## ADDENDUM #01

ACES at CHASE

STATE PROJECT NO. 244-0044 MAG

6. **ALL Bidders** should review and incorporate the **attached Bulletin #1 dated December 16, 2025** prepared by **S/P+A** and their consultants. This Addendum includes:

Drawing Title:  
**BUILDING 1 - UNDER SLAB PLAN -  
PLUMBING**  
Project Phase:  
**ISSUED FOR BID - 11/03/2025**  
State Project Number:  
**#244-0044 MAG**

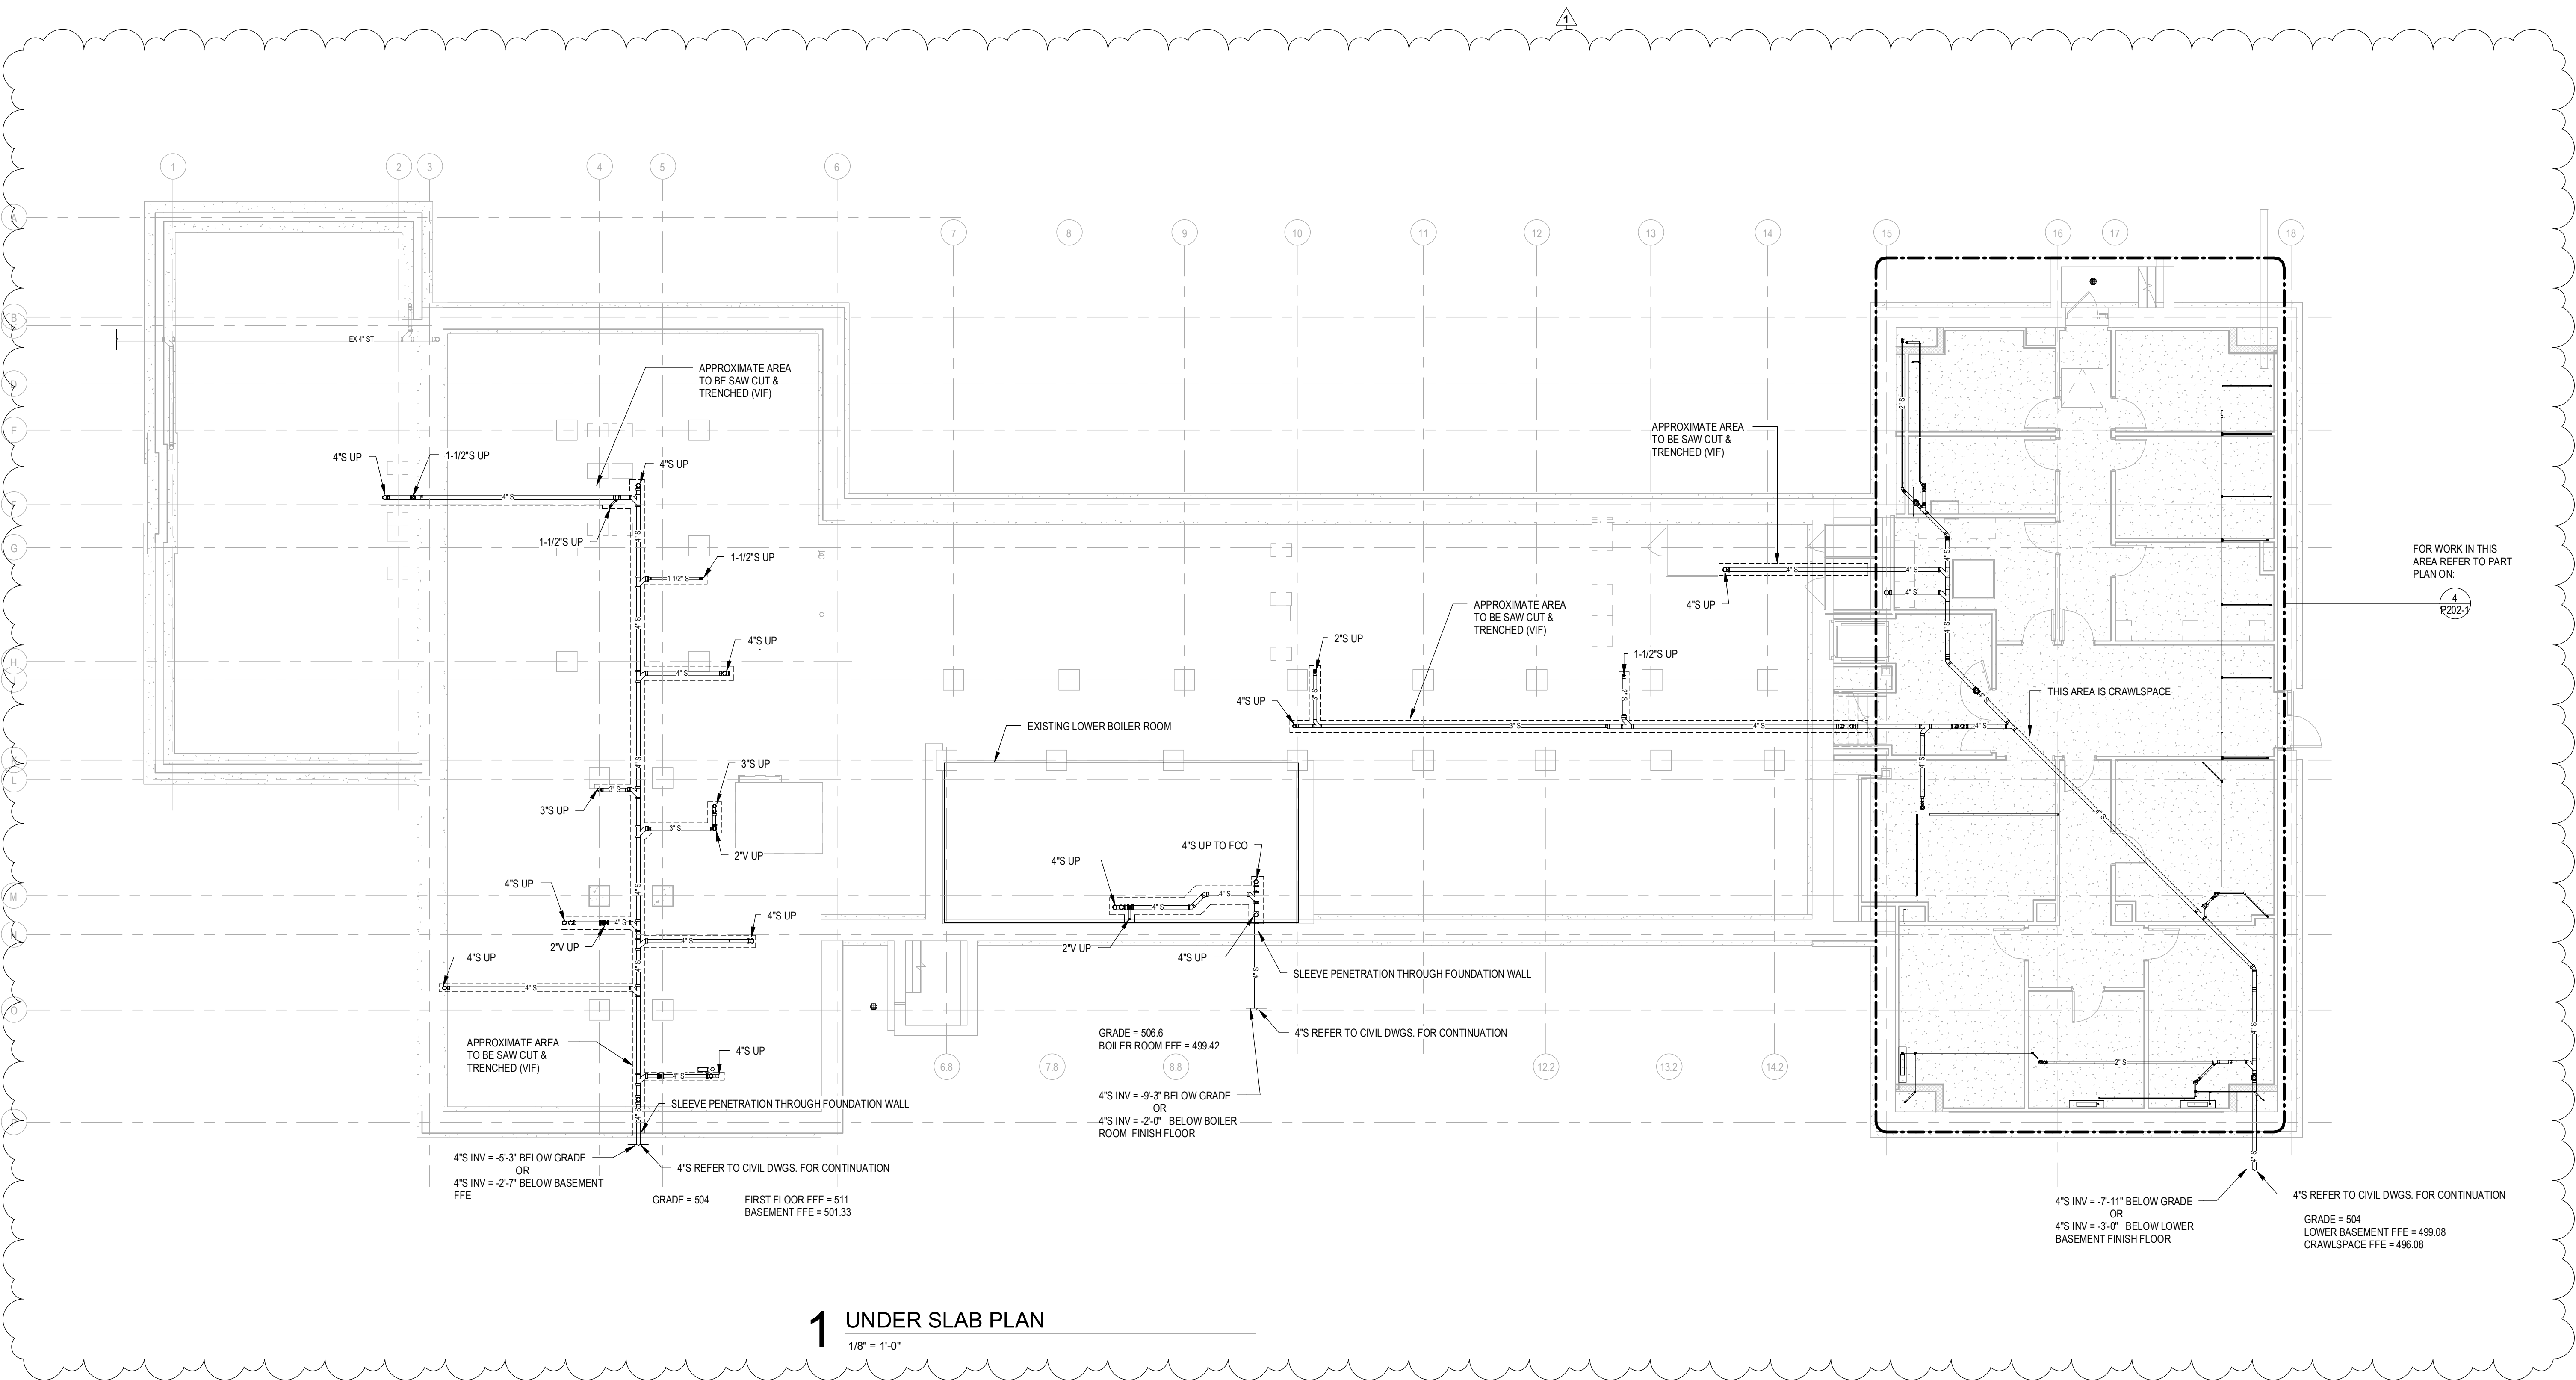
- Building 1, DRAWING P109-1, BUILDING 1 – UNDER SLAB PLAN - PLUMBING has been added and is attached as part of this bulletin.\* *(Per Internal Review)*

**M111-1**

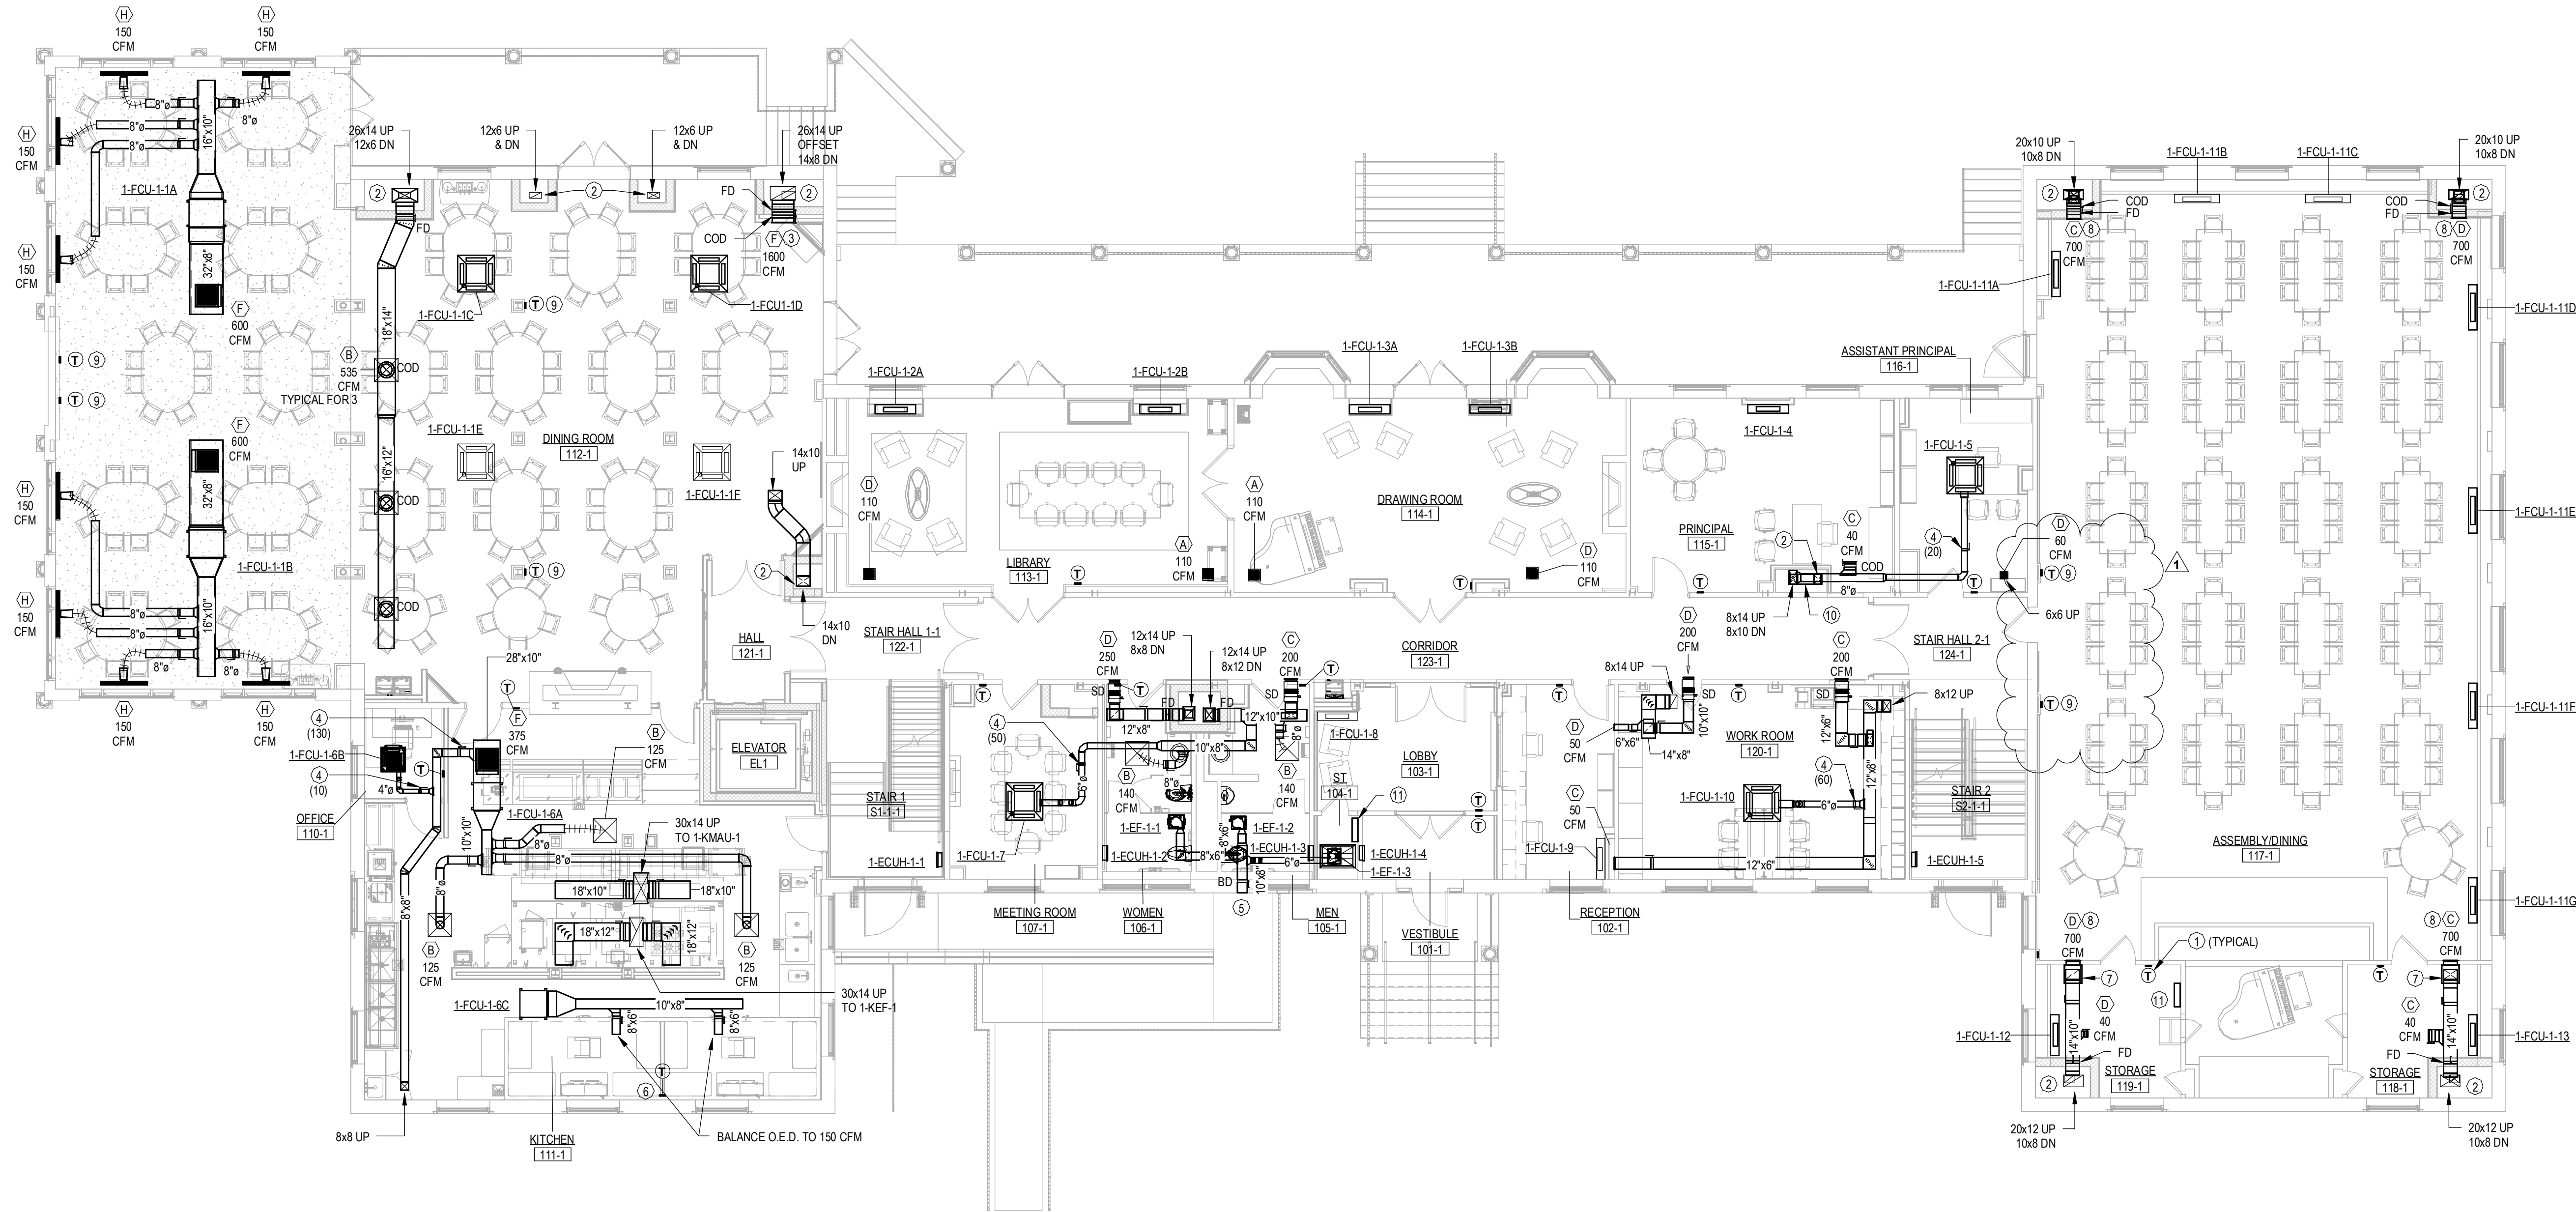
- 
- M111-1 BUILDING 1 – MAIN LEVEL PLAN – DUCTWORK *(Per Cx)*
  - M211-1 BUILDING 1 – MAIN LEVEL PLAN – PIPING *(Per Cx)*
  - M402-1 BUILDING 1 – SCHEDULES - MECHANICAL *(Per Cx)*

E200-1

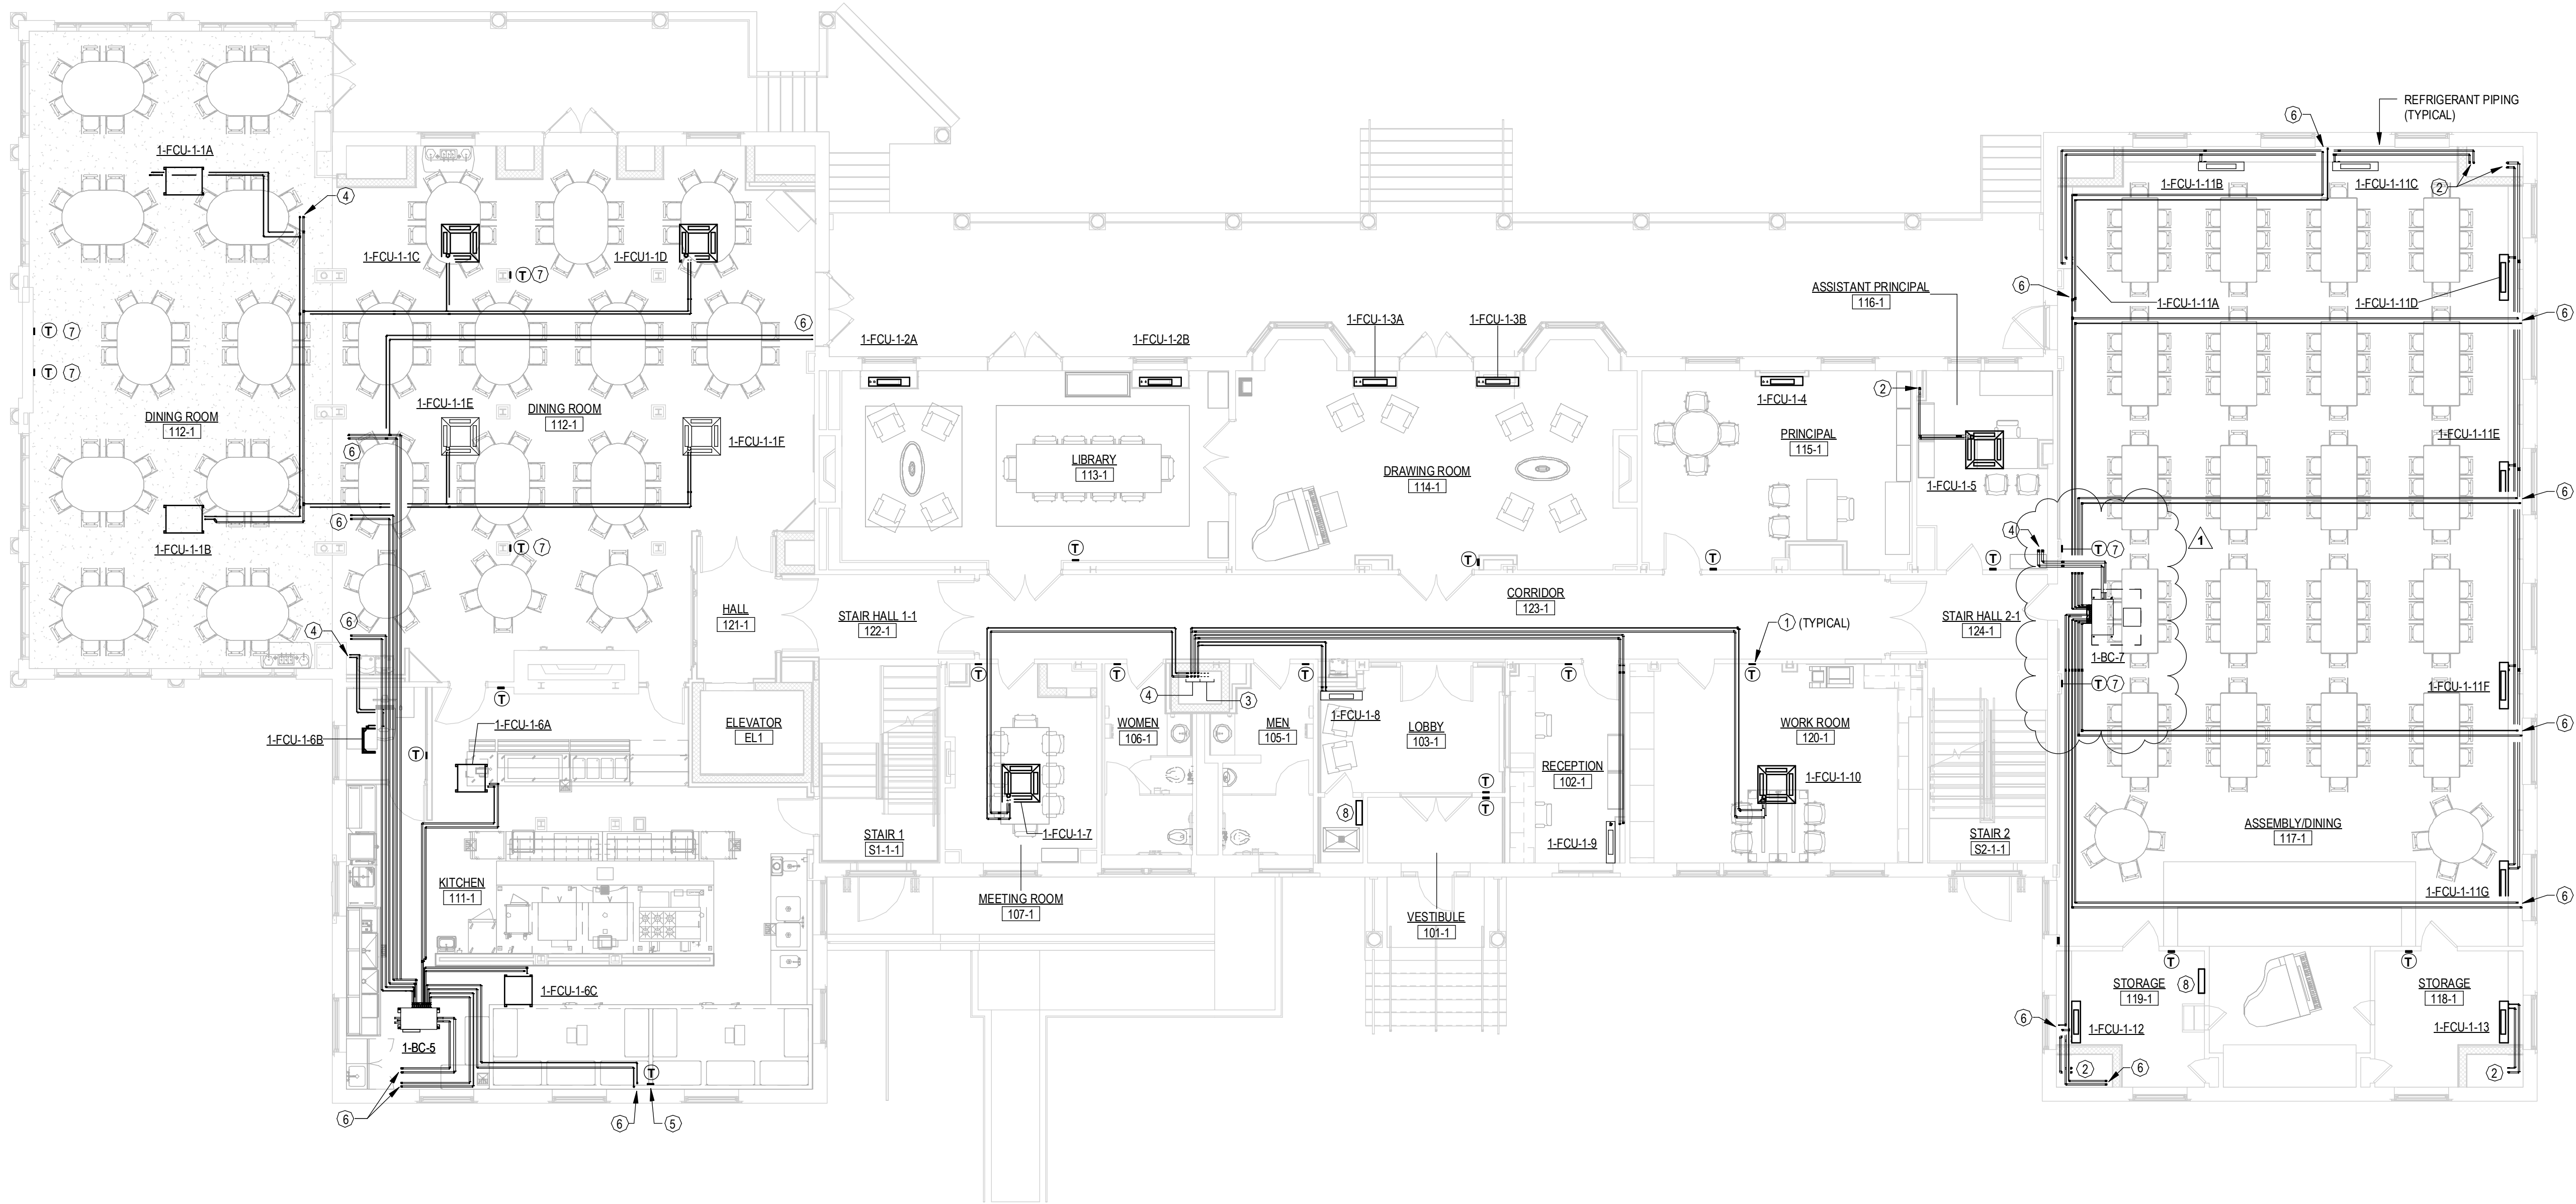
- E200-1 BUILDING 1 – BASEMENT LEVEL POWER PLAN *(Per Internal Review)*
    - E210-1 BUILDING 1 – MAIN LEVEL POWER PLAN *(Per Internal Review)*
    - E220-1 BUILDING 1 – SECOND LEVEL POWER PLAN *(Per Internal Review)*
